Information Note

IN-070_2022_0-OMTM2210910

UKCA marking adding + output cable length

TT-SD series

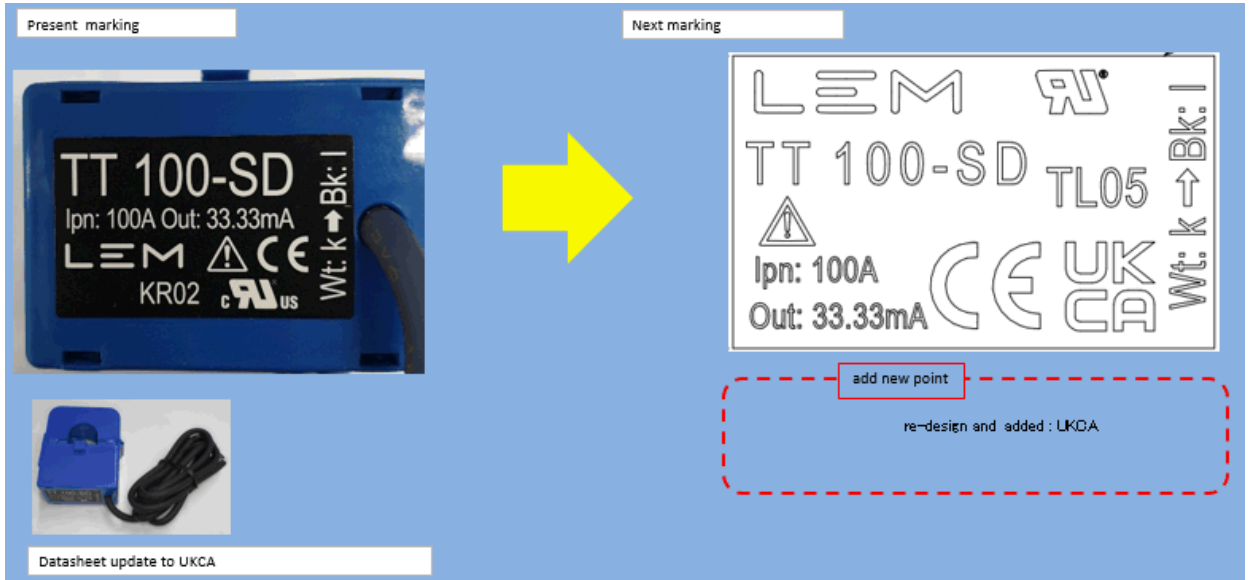
Change 1: Marking change: Add UKCA marking and change of layout of the marking information on the label.

The new marking will still be on black background sheet with text in white color as the current one. Here above illustrations show the new marking information layout on the label. But the color of label and text with new marking will be the same as with the current label.

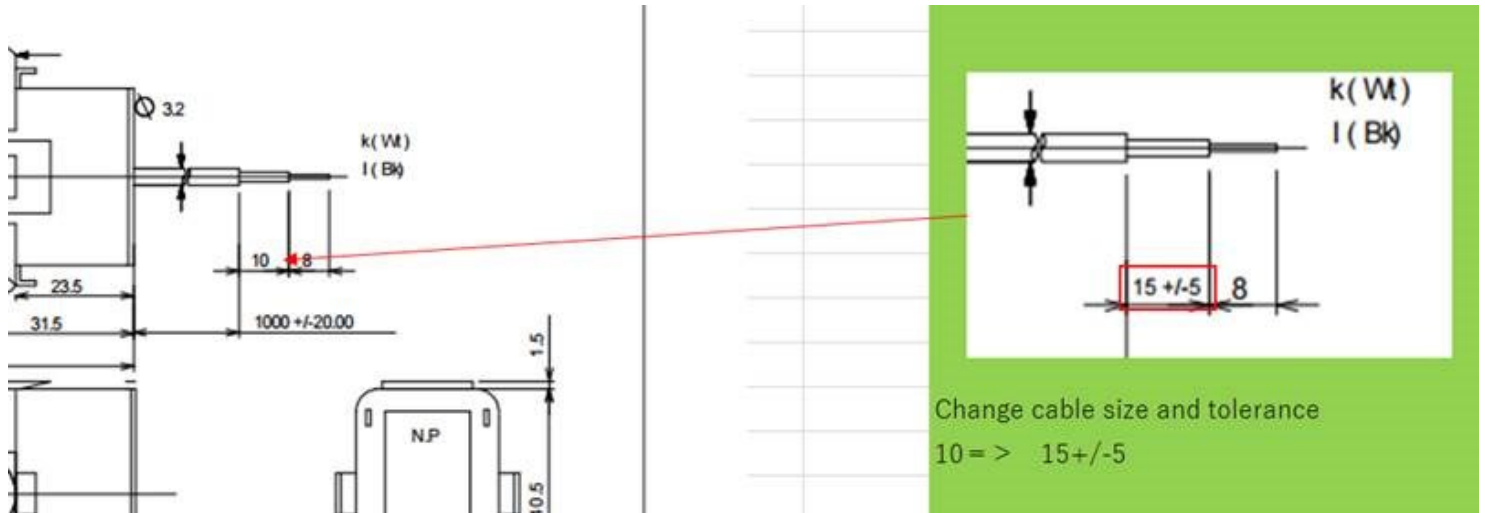
Change 3: Output cable dimensions change a bit as explained hereafter represented. Dimensions on the data sheet were wrong since a while. No change on the products themselves, only correction on the data sheets to illustrate the real product output cable dimensions.
